SIL 20-WT-23
October 16, 2023
Product Code(s): 65
Page 1 of 3

SUBJECT: Output Shaft Yoke/Flange Retaining Bolt Torque Specification Increase

MODELS AFFECTED: B3400 R xFE™, B400 R

Figure 1.

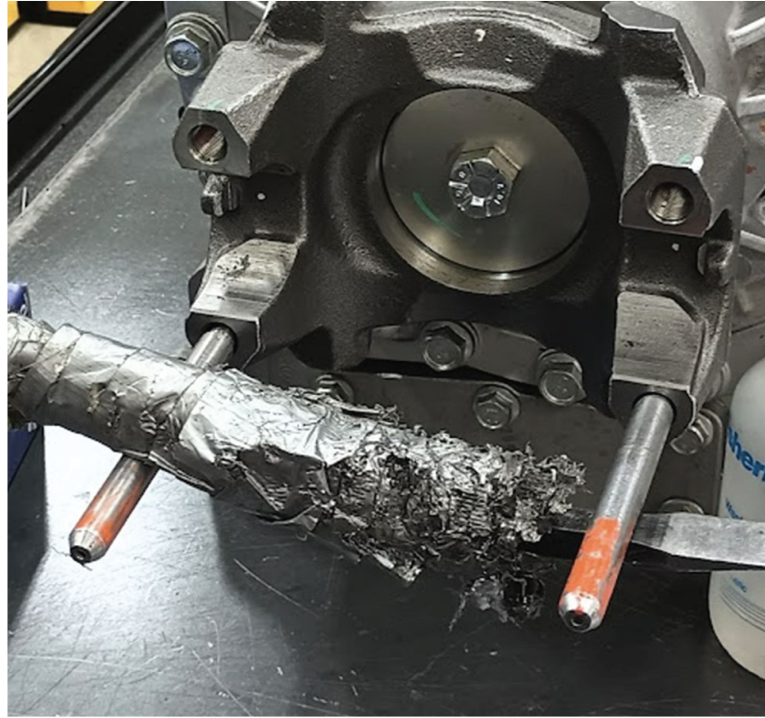
4. Using a pry bar or yoke holding fixture, secure the yoke so it will not rotate.
 - Make sure not to damage yoke u-joint cavity or other machined surfaces (refer to [Figure 1](#)).

5. **Torque output shaft yoke/flange retaining bolt P/N 29535219 to new specification; 130 N·m (95 lb ft).**
6. Clean original paint mark and reapply paint mark to the output retaining plate and output yoke bolt with one continuous mark.

Figure 2.

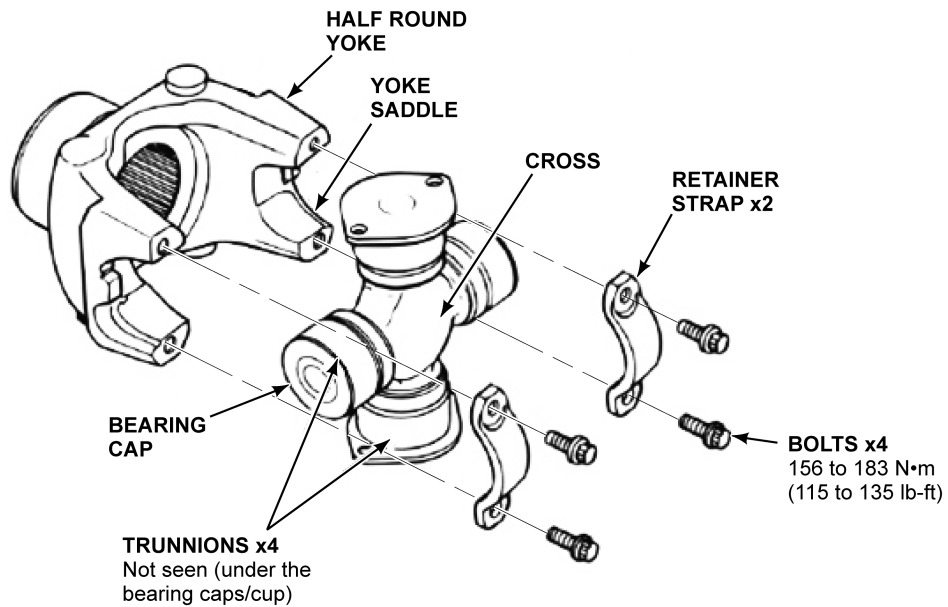
7. Reinstall driveline and secure u-joint to transmission output yoke with new straps and bolts from hardware kit.
- Follow manufacturer's torque procedure and specifications. Refer to [Figure 2](#).
 - Prior to lowering bus from lift, mark transmission nameplate with paint pen to indicate output shaft yoke/flange retaining bolt torque has been verified.
